ADDENDUM #3 - July 22, 2016

**CITY OF MATTOON
PUBLIC WORKS BUILDING
401 DEWITT AVE EAST**

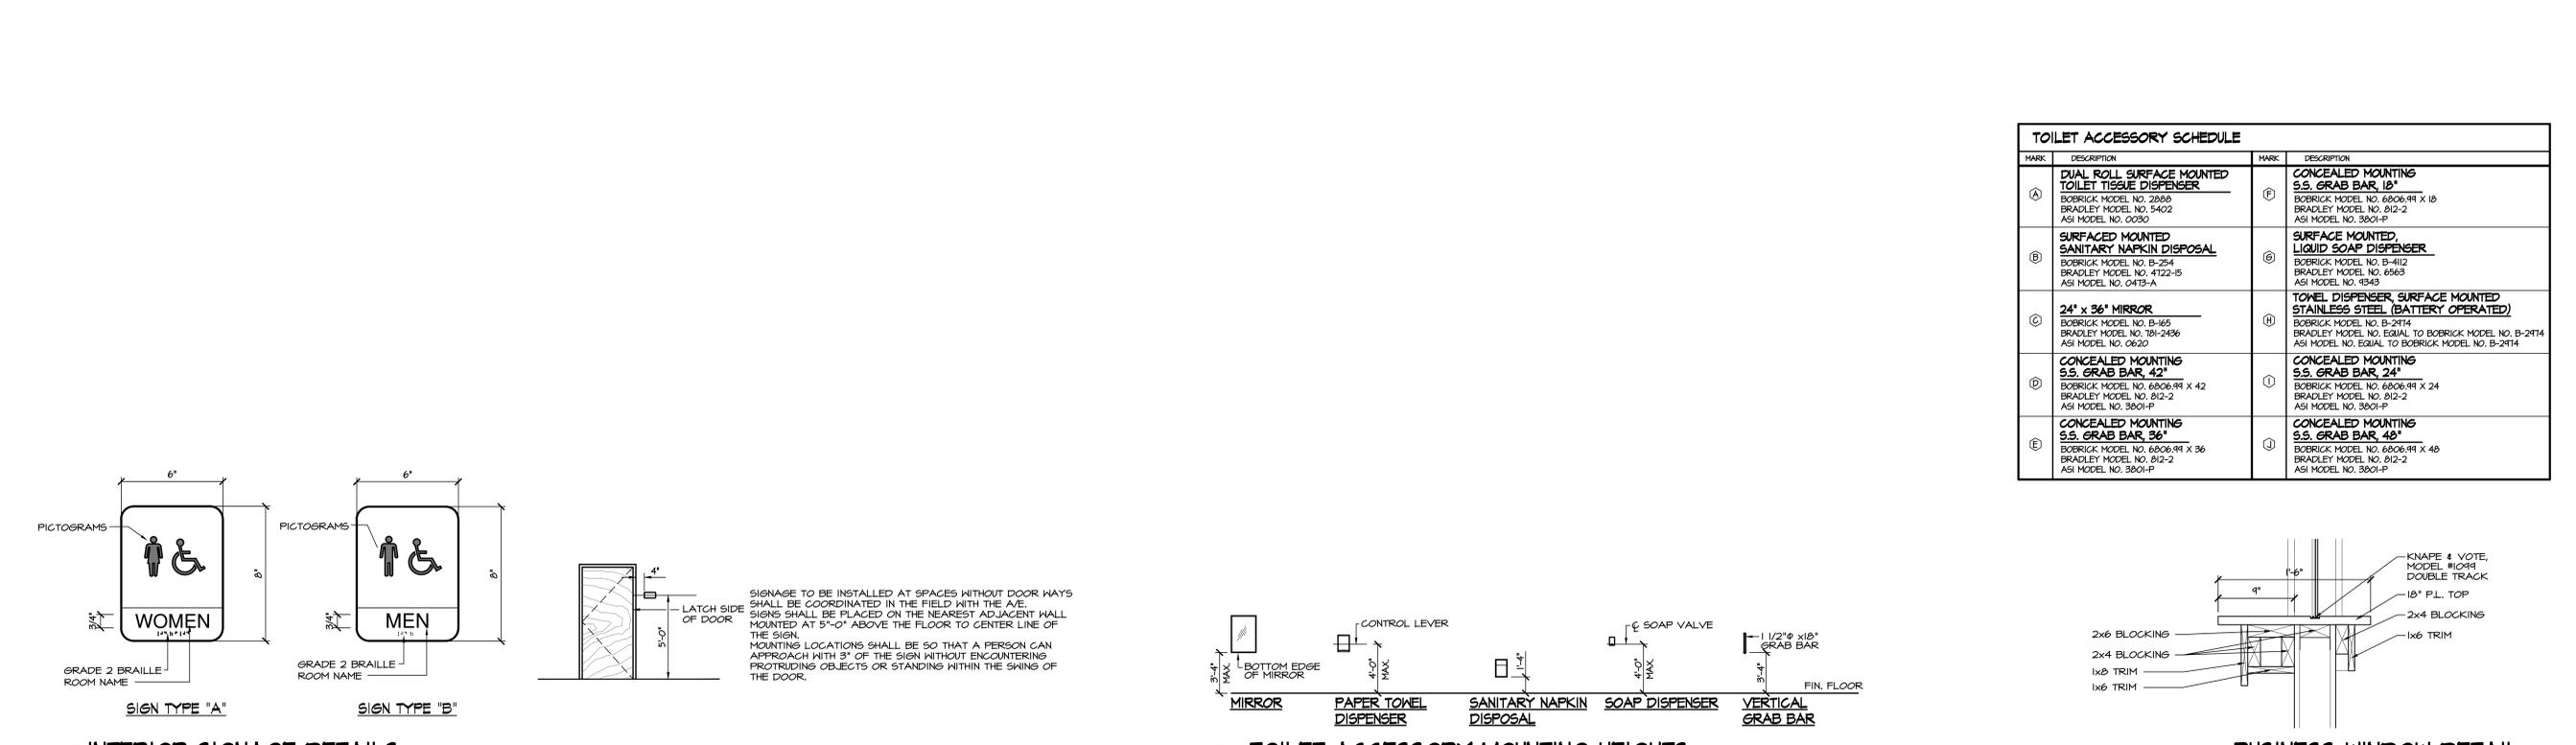
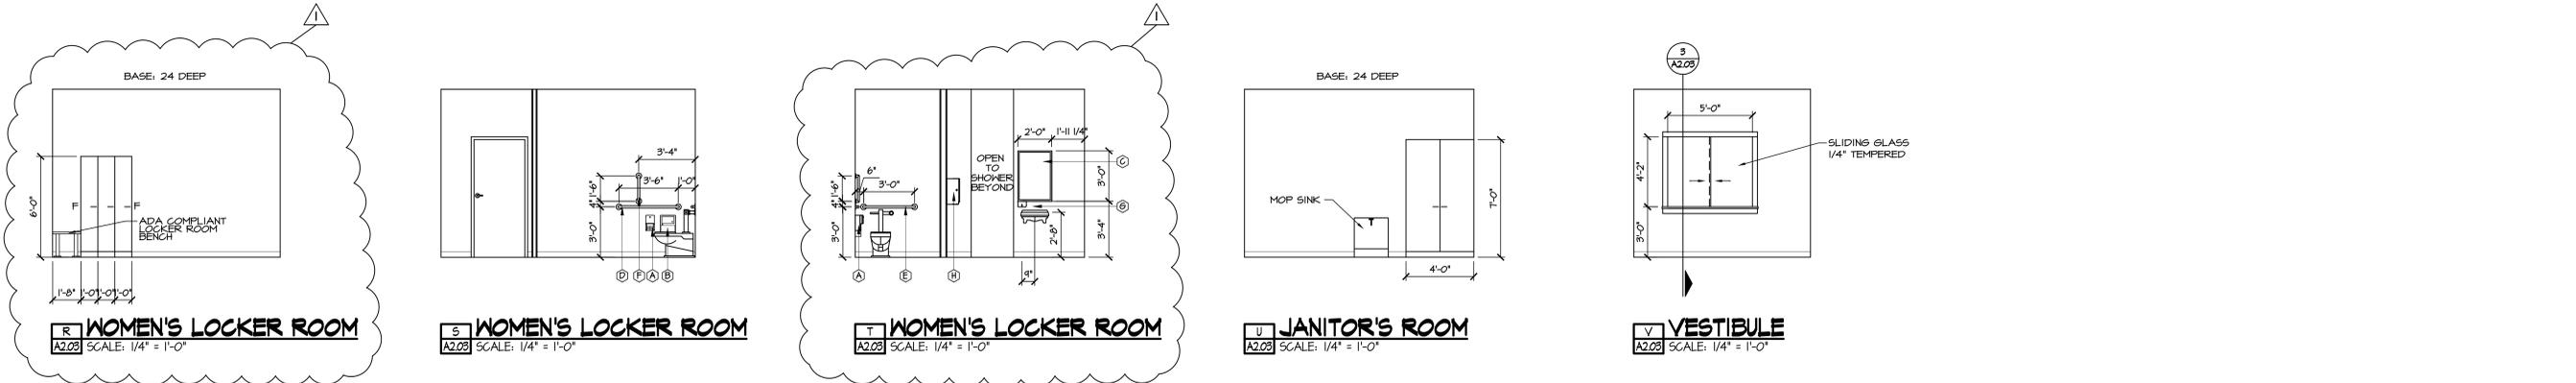
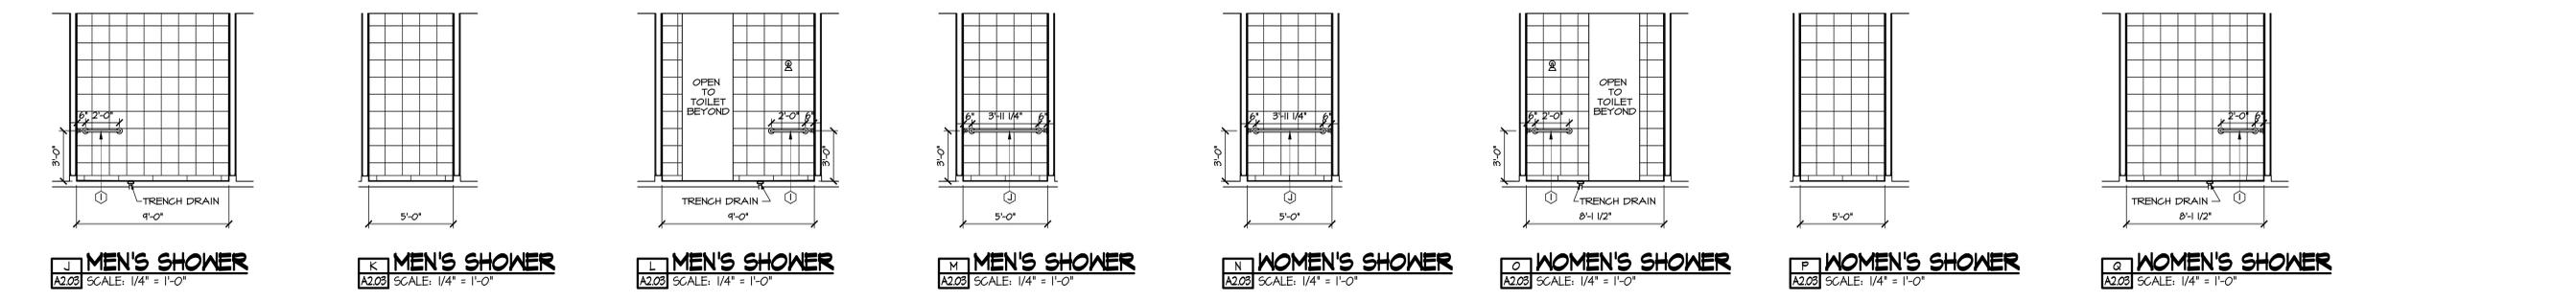
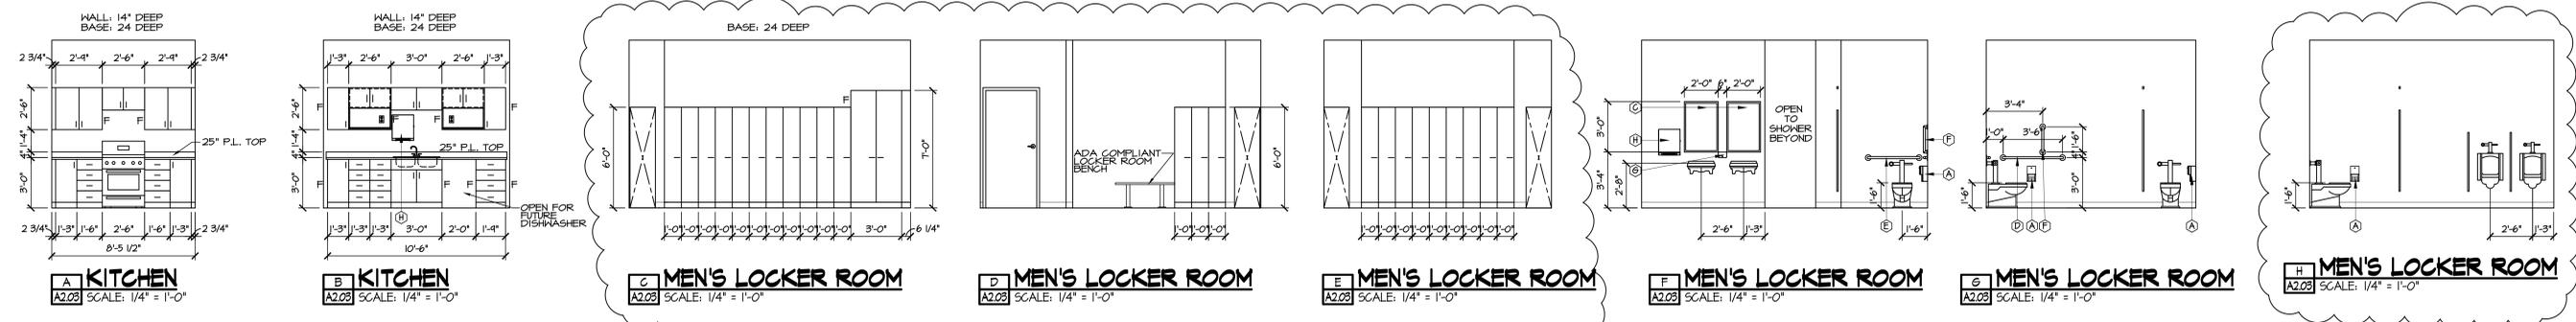
Changed the locker dimensions to 12"W x 15"D x 72"H.

Modified the locker dimensions.

- A. Type: Single Tier lockers with sloped tops.
- B. Locker Size: 12 inches wide by ~~12~~^{15" ADDENDUM#3} inches deep by 72 inches high per opening
- C. Material. Sheet Steel: ASTM A 1008, Class I, mild annealed, cold rolled steel, free from surface imperfections. Bolts: Zinc plated or other comparable rust-retardant treatment.
- D. Body: 16-gauge steel except backs may be 18-gauge steel.

B ENLARGED LOCKER ROOM PLAN
AS.01 SCALE: 1/4" = 1'-0"

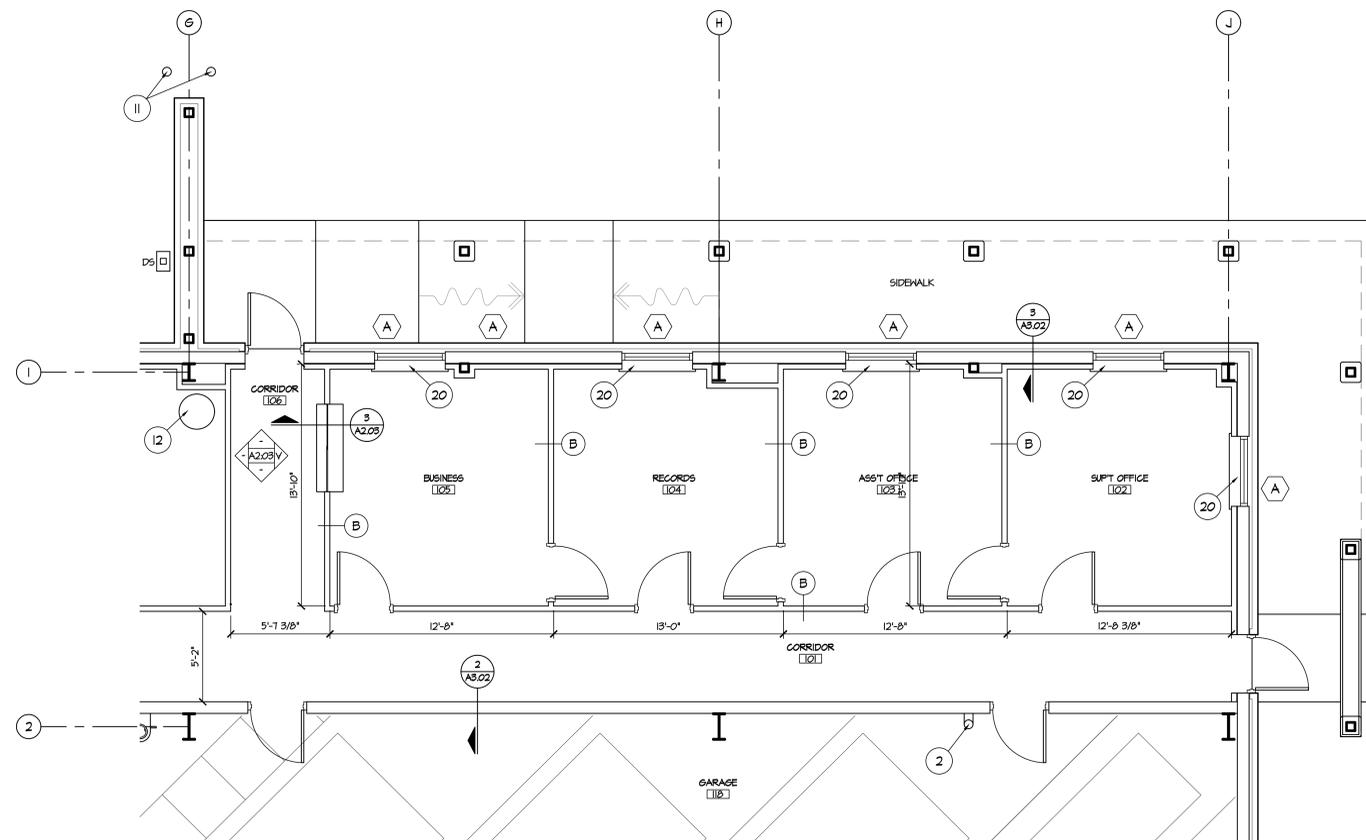
Added ADA compliant benches in the locker rooms.

- 1 NOT USED
- 2 FIRE EXTINGUISHER, DRY CHEMICAL TYPE, 10 POUND CAPACITY, WITH PRESSURE GAUGE, UL RATING: 4A 60BC
- 3 APPLIANCES, NOT IN CONTRACT
- 4 NOT USED
- 5 ELECTRIC PANELS, SEE ELECTRIC DRAWINGS
- 6 NOT USED
- 7 NOT USED
- 8 EMERGENCY SHOWER/EYE WASH STATION, SEE PLUMBING DRAWINGS
- 9 WORK BENCH, BY OWNER
- 10 NOT USED
- 11 PIPE BOLLARD, SEE CIVIL DRAWINGS
- 12 WATER HEATER, SEE PLUMBING DRAWINGS
- 13 MOP SINK
- 14 LOCKERS, SEE INTERIOR ELEVATIONS, SHEET A2.03
- 15 TABLES AND CHAIRS, BY OWNER
- 16 EMERGENCY EYE WASH STATION, SEE PLUMBING DRAWINGS
- 17 TALL STORAGE, SEE INTERIOR ELEVATIONS, SHEET A2.03
- 18 HANDICAP SIGNAGE, SEE DETAIL 1/A2.03
- 19 HI-LOH DRINKING FOUNTAIN
- 20 SOLID PLASTIC WINDOW SILL
- 21 ADA COMPLIANT LOCKER ROOM BENCH
